VALUE ENGINEERING STUDY

SELA Flood Control, Orleans Outfalls East Bank of Orleans Parrish, Louisiana

Final Report

DOD SERVICE: Army
VALUE ENGINEERING OFFICER: Frank Vicidomina
VE CONTROL NO.: CEMVN-VE-01-06

HARRISON AVE. PUMP STATION

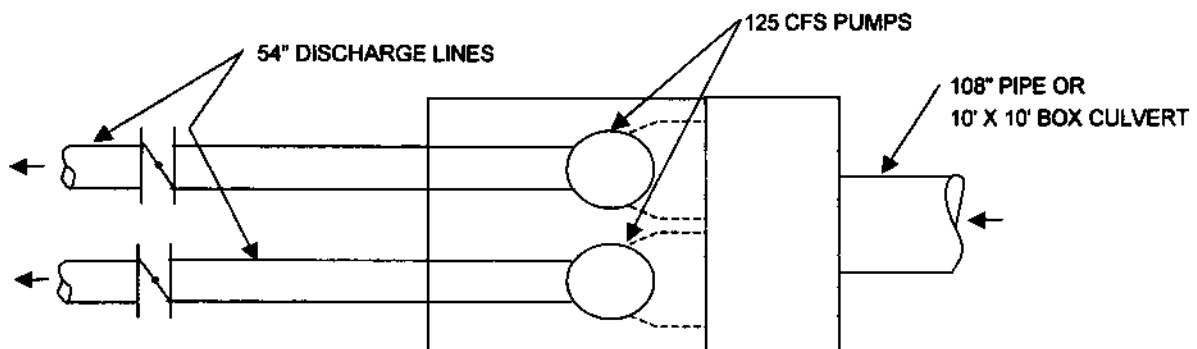
Discussions with the USACE New Orleans District Design Staff indicates that the larger sized stations may not be more effective than a reduced size due inflow constraints.

TYPICAL SECTION

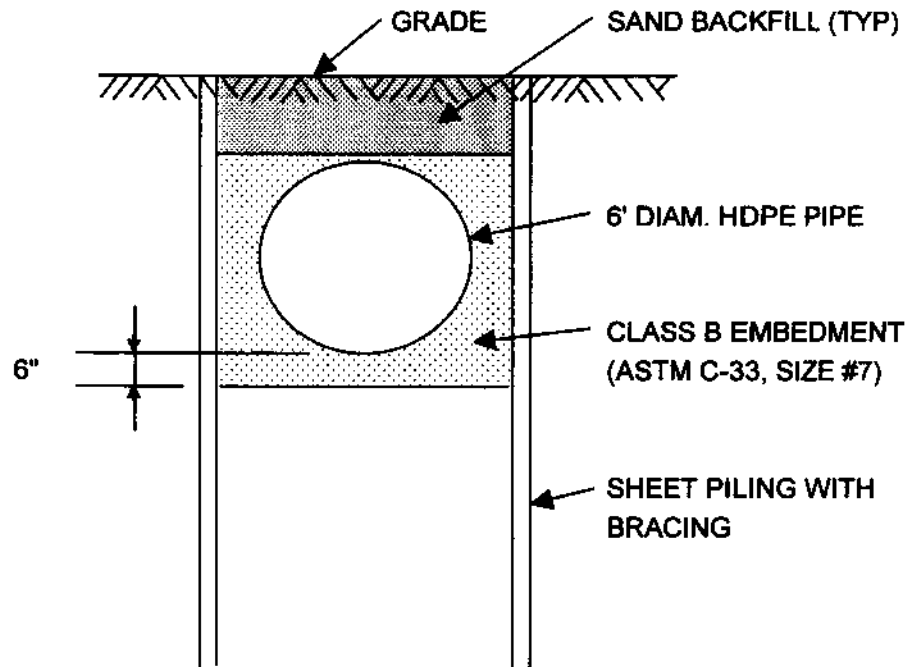
DESCRIPTION: Replace concrete pipe near Robert E Lee pumping station with alternative pipe material.

The principal concern with HDPE pipe is that it will float when empty if enough head is developed by flooding. Concrete pipe will also float under these conditions, but has more mass and will require less anchorage to resist floatation. HDPE has been successfully used in most of the same applications as concrete pipe and avoids hydrogen sulfide corrosion which is prevalent in gravity concrete pipelines.

ORIGINAL CONCEPT — SKETCH

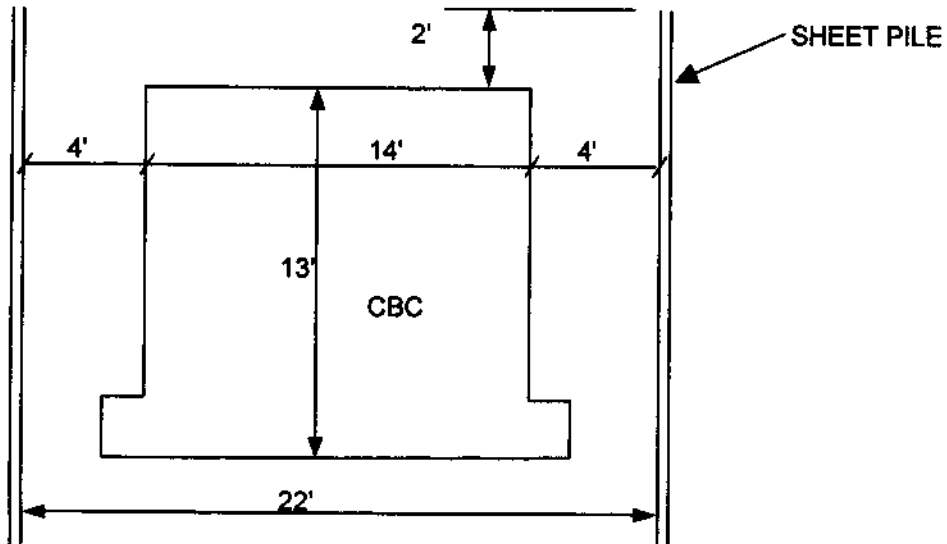
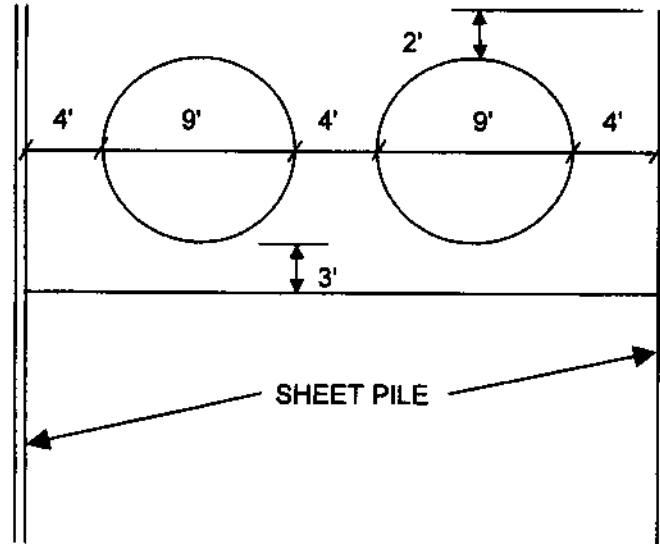
DESCRIPTION: Replace box culvert near Harrison Pumping Station (HPS) with pipe

This alternative was developed considering two 9-foot diameter HDPE parallel pipelines in a common trench. Sufficient compaction of backfill is necessary for this alternative to be feasible. Although the lighter weight pipe will require additional anchorage, it will also settle less than a concrete box culvert.

Due to less concrete volume and faster pipe laying times, it was assumed that the Proposed Concept could be complete one year earlier than the Original Concept. The benefit from this was determined as the interest lost for an additional year of construction.

PROPOSED CONCEPT — SKETCH

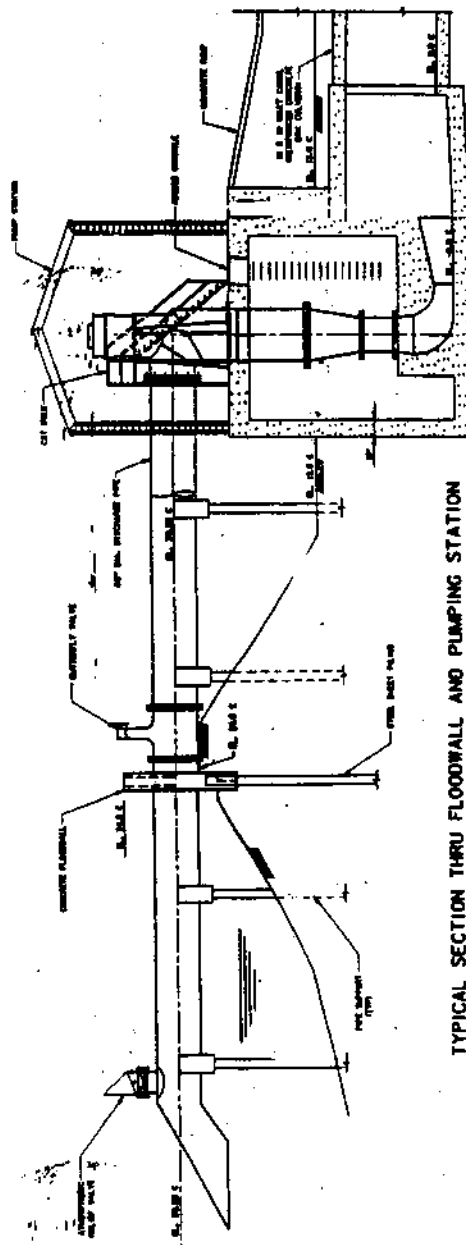
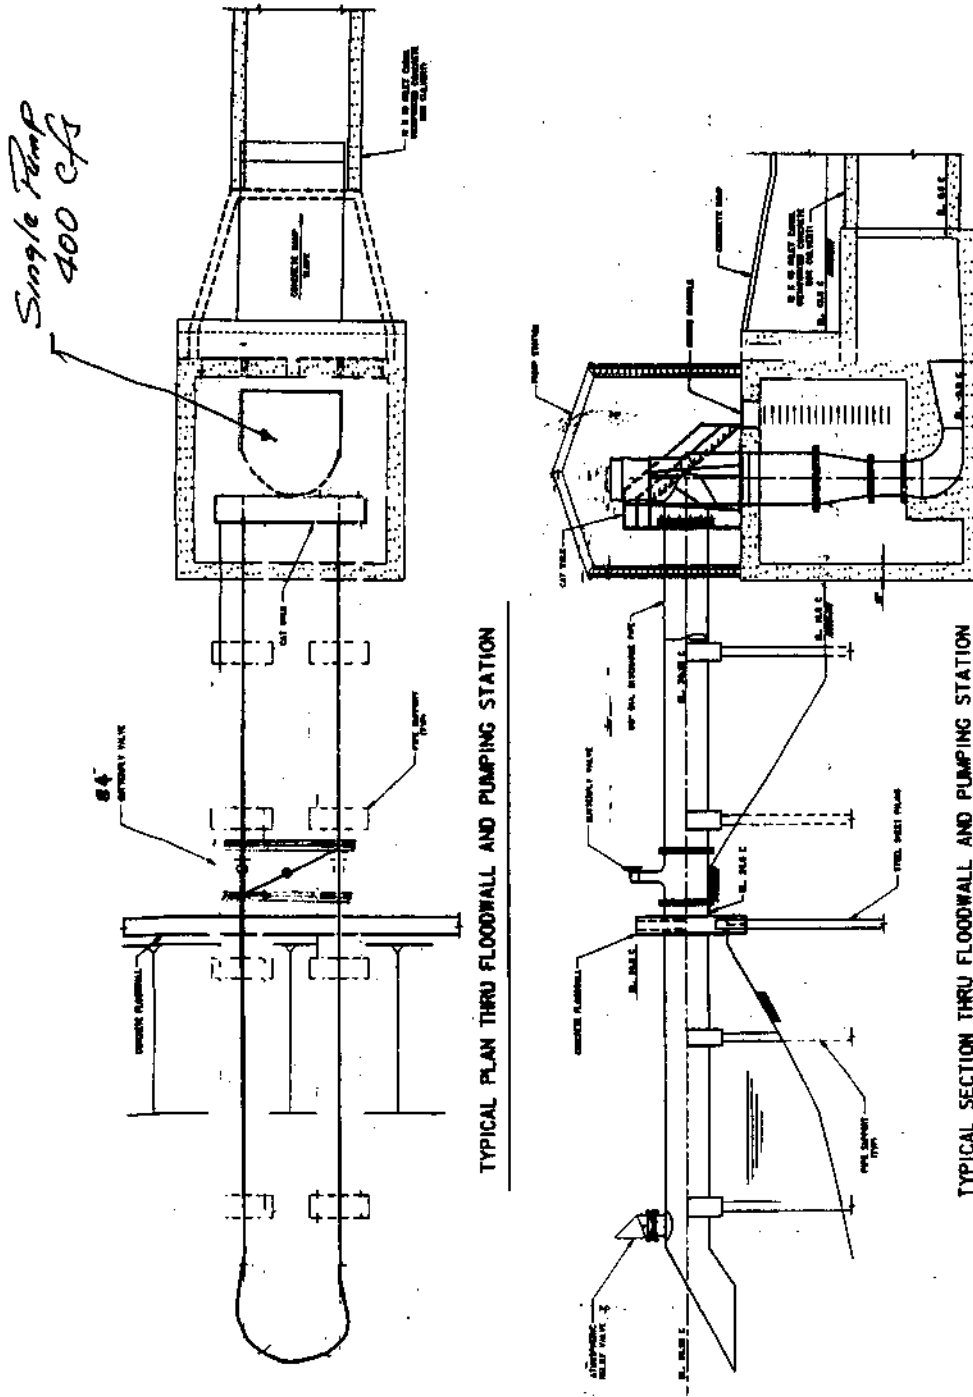
A major concern of this proposal is the apparent reliance on a single pumping unit to satisfy the required function. However, since this station is supplemental to a larger system, unit redundancy is *not* critical. Additionally, statistical analysis of rotating machinery substantiates that fewer units reduces the number of outages and increases the on-line availability and the reliability of the system.

The Life Cycle Cost calculations did not consider energy costs since equal volumes of water would be moved, nearly equal amounts of energy would be required to move the water. O&M costs are based on 1% of the cost of the first cost items listed.
